No. 93-11

A. REQUIRED STARBOARD ENGINE MOUNT BOLT REPLACEMENT

All MCM V6 and V8 Stern Drive Engines
Serial Number: 0F020958-0F024051

Figure 1. V6 Engines

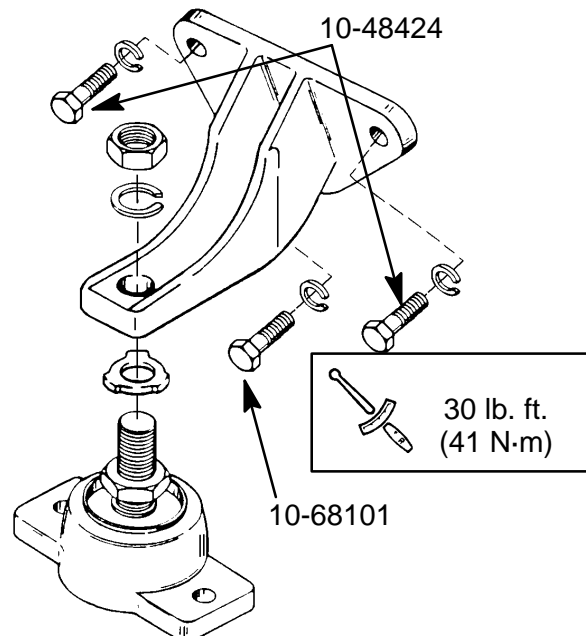
All V6 engines have the wrong length bolts holding the starboard (right) mount to the cylinder block.
All 3 bolts are the wrong length.

Notice: Before changing the bolts, look at the color of the bolt head. If it is gold in color, bolt has already been changed at the factory and does not have to be changed.

By replacing one bolt at a time, you won't have to support front of engine. See Figure 1 or 2 for correct bolt replacement.

V6 Engine: (1) 10-68101 Lower Bolt
(2) 10-48424 Upper Bolts

All Engines: Loctite 271- Applied to bolt threads before installing.

Figure 2. V8 Engines

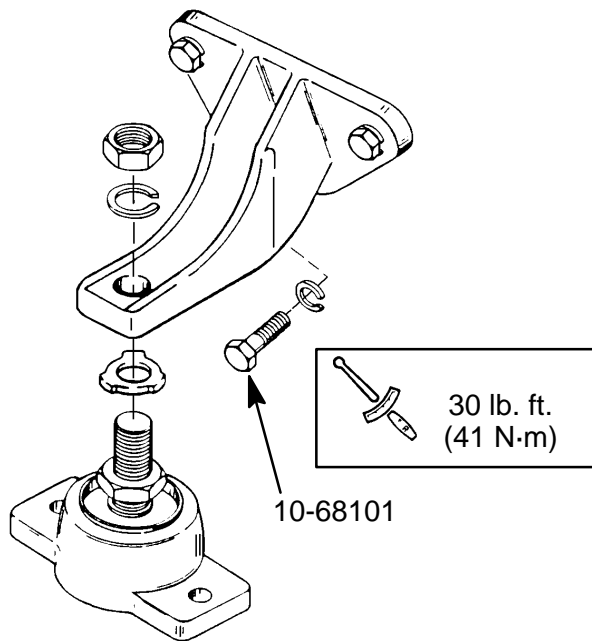
All V8 engines have the wrong length lower bolt holding the starboard (right) mount to the cylinder block. The top two are the correct length.

V8 Engine: (1) 10-68101 Lower Bolt
